SECTION 009113 – ADDENDUM ONE

- A. Project Name: 21034.01 – West Bolivar Consolidated School District ESSER – Phase 2.
- B. Owner: West Bolivar Consolidated School District, 909 Hwy 8, Rosedale, MS 38769.
- C. Architect: Dale | Bailey Architects, An Association, One Jackson Place, Suite 250, 188 East Capitol Street, Jackson, MS 39201.
- D. Architect Project Number: 21034.01
- E. Date of Addendum One: 29 June 2023

6 Typical Water Fountain Elevation
3/8" = 1'-0"

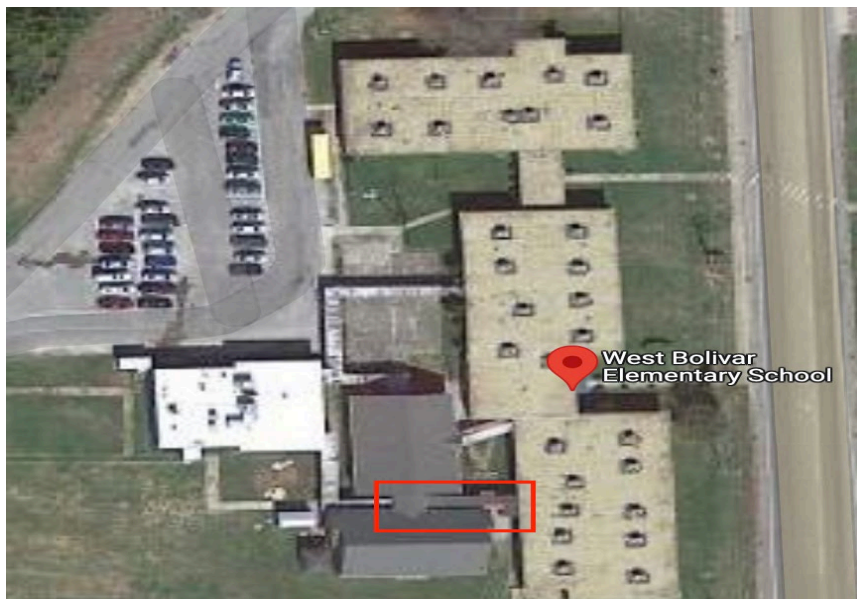
- A. SHEET G-611 – GENERAL FINISH & DOOR DETAILS. (Not Re-Issued). Add the following:

General Notes:

1. Lay new ceramic wall tile on all 3 sides of inset for drinking fountain.
2. Contractor shall install Schluter into corners and edges of ceramic wall tile.

- Replace Detail 6 with new; see below:

Window Replacement Notes

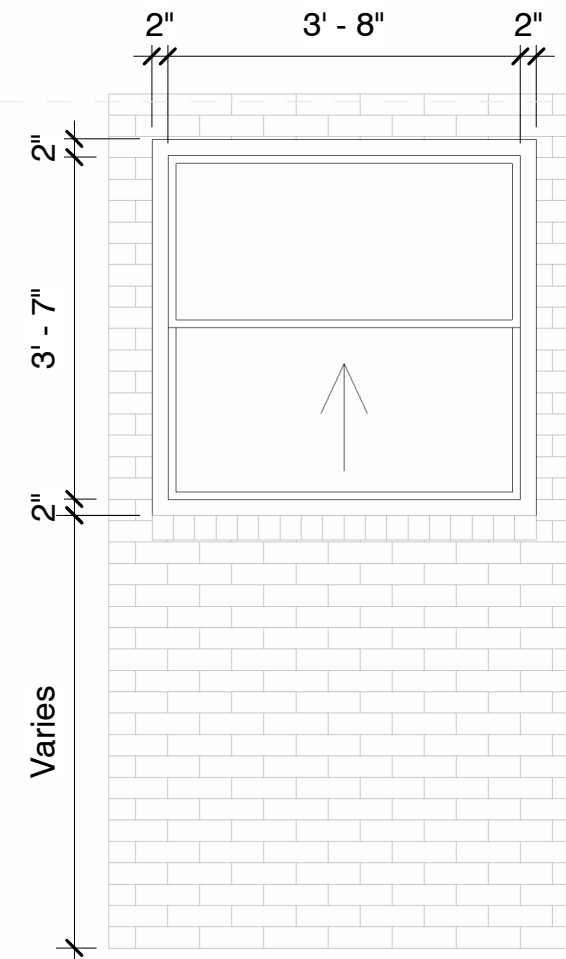
- Contractor shall replace existing windows (6) located at West Bolivar High School with new single-hung windows.

2 POWER PLAN - ALTERNATE #1
 E-101 Scale: 1/8" = 1'-0"

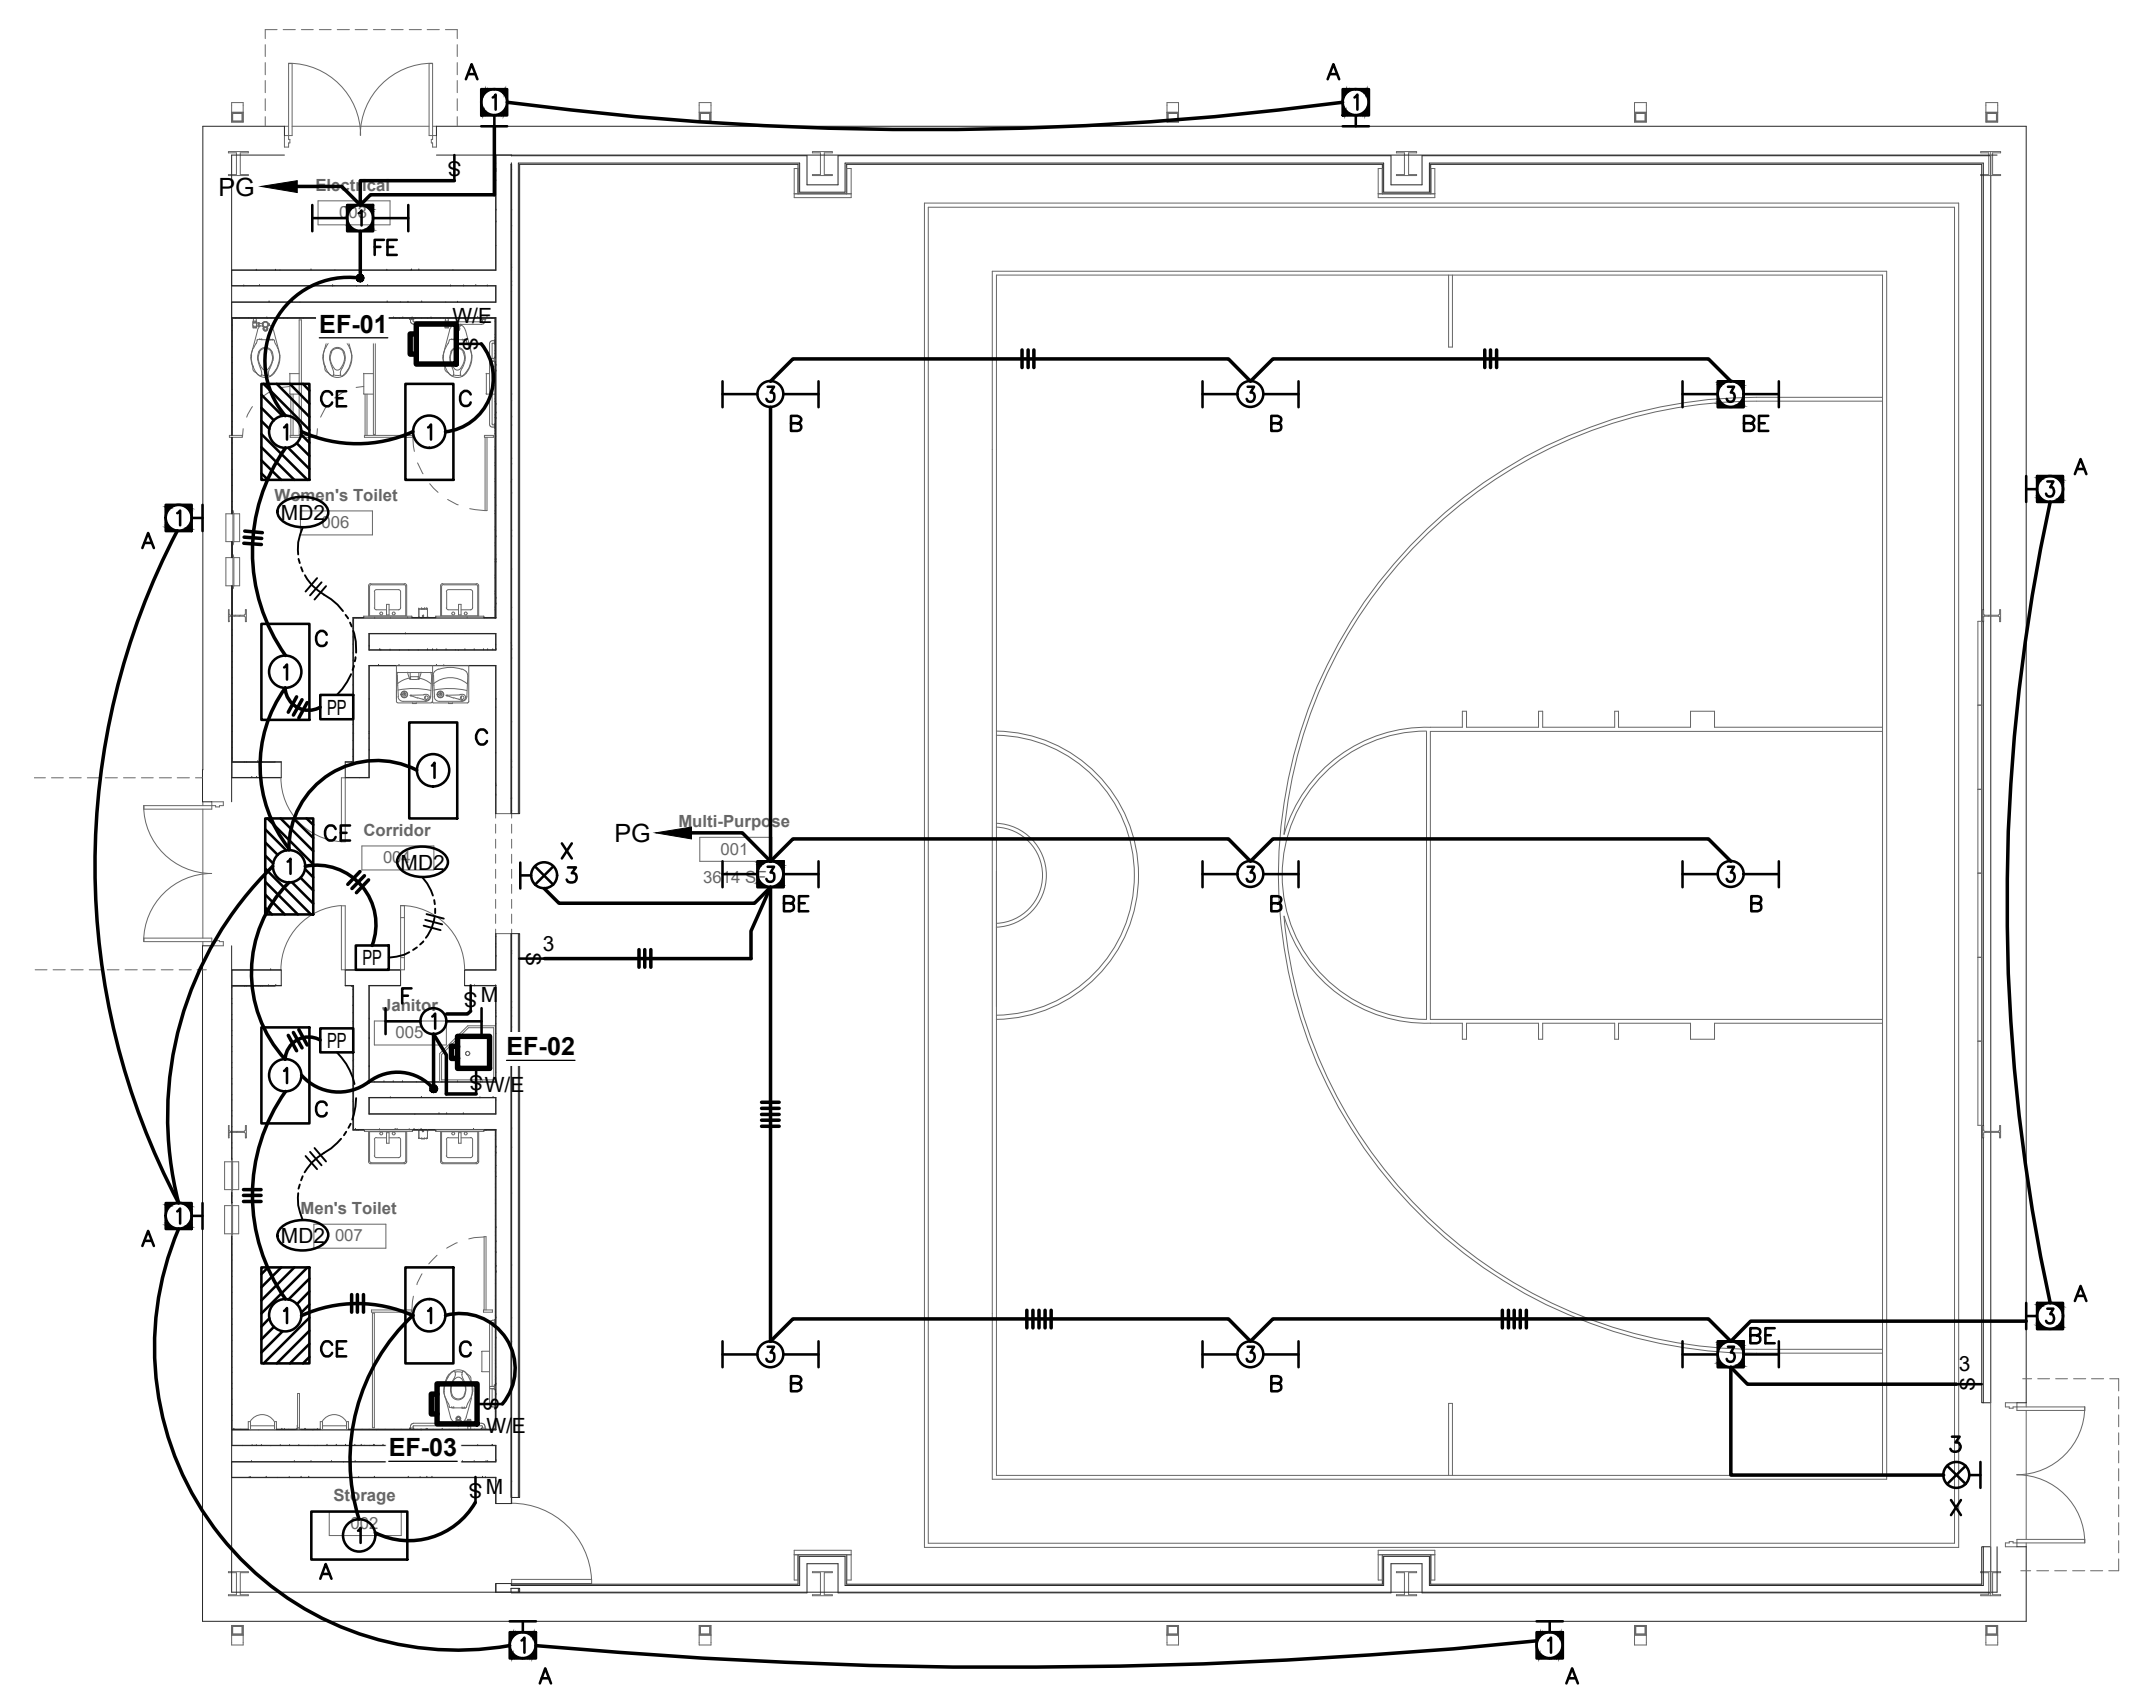
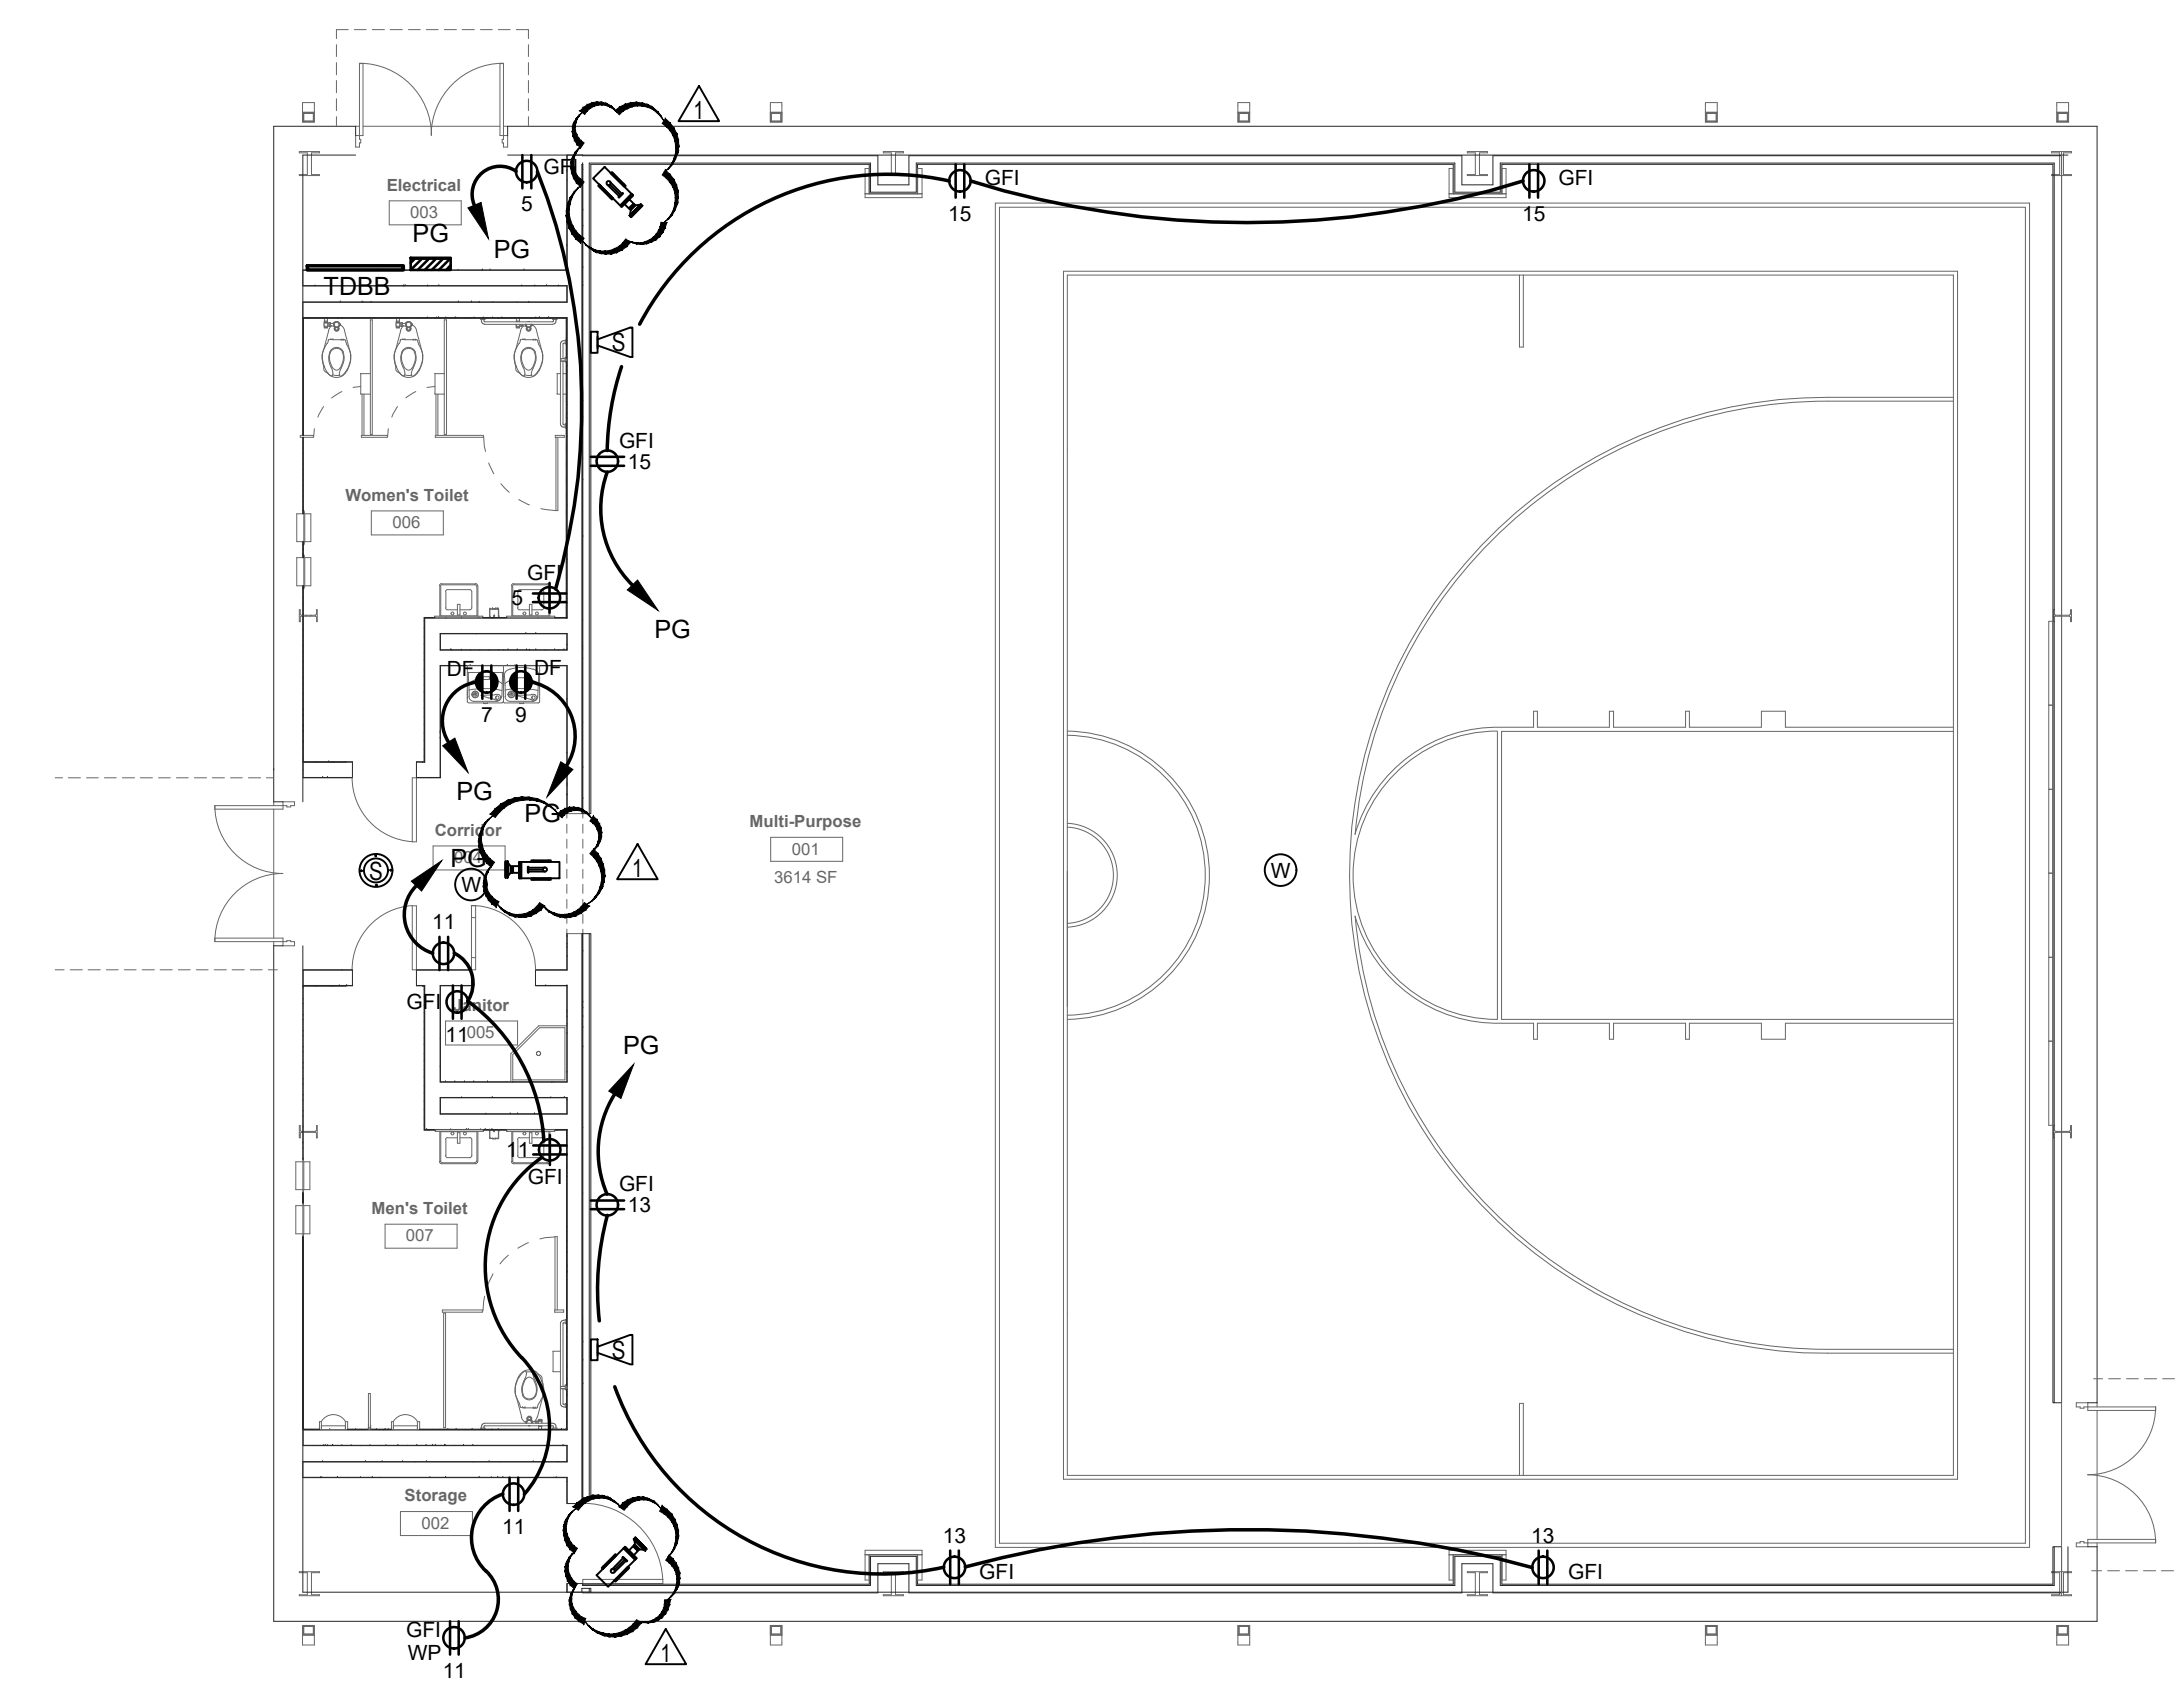
- A. Question: There are no Fire Alarm shown on E-101.
Answer: There is no fire alarm system in this building.
- B. Question: There are no cameras shown on E-101.

- C. Question: There is a W item on power plan on E-101 shown in multi-Purpose and corridor, see highlighted picture below. Is this Wi-Fi or sound? If this is Wi-Fi, who is responsible for installation?

- D. Question: There is an S item on power plan on E-101 shown in multi-purpose, see highlighted picture below.

Answer: See attached revised E-101 for camera locations.

Answer: This is a Wi-Fi. Electrical to install box and cat6.

Answer: Wall mounted speaker.
